Del Mar Mesa Specific Plan

Carmel Mountain/Del Mar Mesa Resource Management Plan Trails Amendment

Public Review Draft Strikeout/underline April 2012

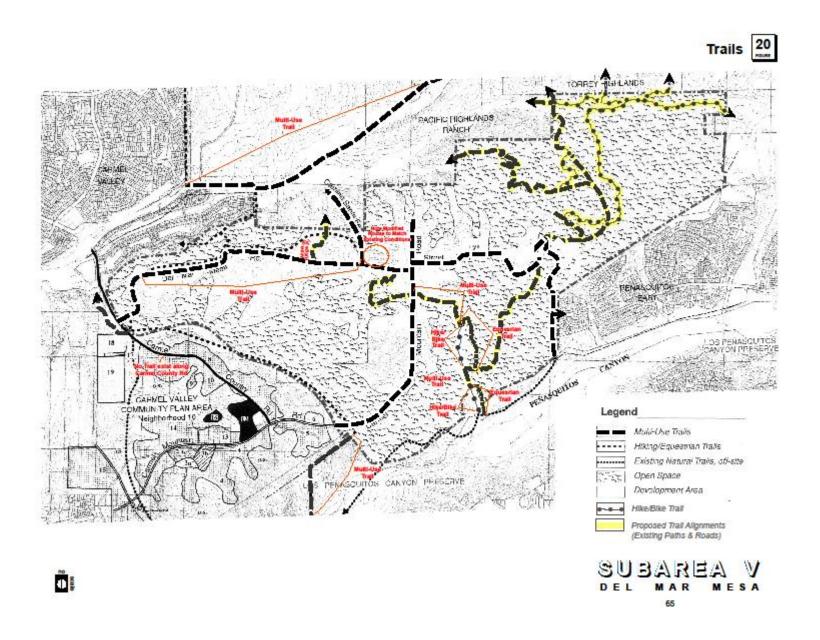
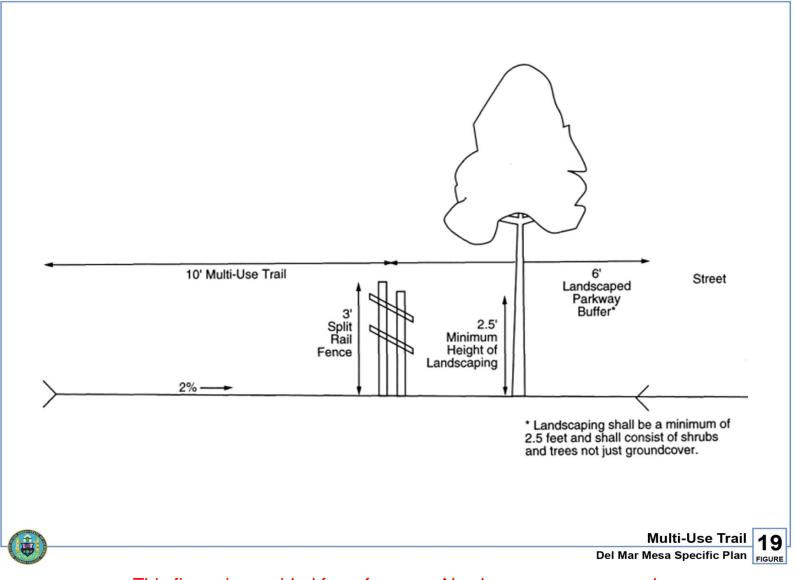
In order to provide a linkage to the open space system, connect Del Mar Mesa to the surrounding communities and provide the residents in the area with recreational opportunities, the Plan includes two trail systems <u>described below and illustrated on Figure</u> <u>20</u>:

• <u>TheA</u> multi_use trail shall be located adjacent to all circulation element roadways and shall be designed to accommodate walking, jogging, bicycling and horse riding <u>as</u> recreational activities in addition to providing a community circulation function. Where equestrian users share the alignment, <u>Tthe trail's tread width</u> shall be ten feet in width and separated from the roadway by a six-foot <u>wide</u> landscaped parkway. Where a separate equestrian trail alignment is provided, the tread width may be reduced to eight feet. A twelve foot vertical clearance is preferred for equestrian trails.

A trail system shall also be located within open space which primarily serves a • passive recreation function. In addition to the multipurpose trail, a hiking/equestrian trail system is proposed. This system is intended to complement the roadside multiuse trail system by providing public- hiking, biking and horse riding opportunities away from vehicular traffic. alignments (see Figure 20). This system includes a trail for hikers and equestrians on the northwestern edge of Del Mar Mesa that connectsing to trails in Carmel Valley Neighborhood 8 and provides a link to existing and planned trails in Carmel Valley Neighborhood 10., as well as trails through the Shaw Valley and In addition, trails are identified through the Lorenz Parcel (Area No. 70 on Figure 30). Within the eastern portion of the community, a trail will extend and farther to the east extending from Street Z (Rancho Toyon Place), following to connect with the existing SDG&E easement and follow the utility access road linking south into Peñasquitos Canyon and north to connect with the trail system in the Torrey Highlands community and ultimately to the trail within McGonigle Canyon. Thise far eastern trail is designated foras multi-use, and will -including the accommodateion of mountain bikes. Several hiking and biking trails will also be

Where alignments for the proposed trail system described above and shown on Figure 20 cross open space, they are located within authorized existing access roads or along existing dirt paths to avoid grading impacts to environmentally sensitive lands. In general, trails designated for inclusion in the non-vehicular circulation system will be left in their present condition. Limited improvements may be made to address any existing hazards to safe passage. Clear signage should be provided to direct users to designated trail areas.

Trails identified on Figure 20 may be implemented as part of the process to develop property, or separately by the City or other public agencies. Changes to management, maintenance or user needs may also call for new or reconfigured trail alignments as well as improvements to existing trails. Such changes have the potential to impact environmentally sensitive lands and would require additional environmental review. Proposals that would result in permanent deletions or additions to the trail system should also be reviewed by the Del Mar Mesa Community Planning Board.

For development <u>projects</u>, a trail plan shall be required prior to the approval of all future tentative maps in order to assure the appropriate connections and design necessary to implement the goals and objectives of the Specific Plan. The precise alignment of the trails identified on Figure 20 shall be determined and secured either through dedication or easement as a map condition. Provisions for the maintenance of common trails shall be made either by defining maintenance as a responsibility of the appropriate homeowner's association in the area, or through the formation of a Landscape Maintenance Assessment District.

Roadside multi-use trails and new equestrian/hiking trails should be improved to achieve City trail standards unless the trail is located in the MHPA or in an area with steep topography. <u>Outside the MHPA</u>, where topographic conditions allow, new trails should be eight to ten feet in width, constructed of decomposed granite to a depth of six inches and should be no steeper than ten percent grade.
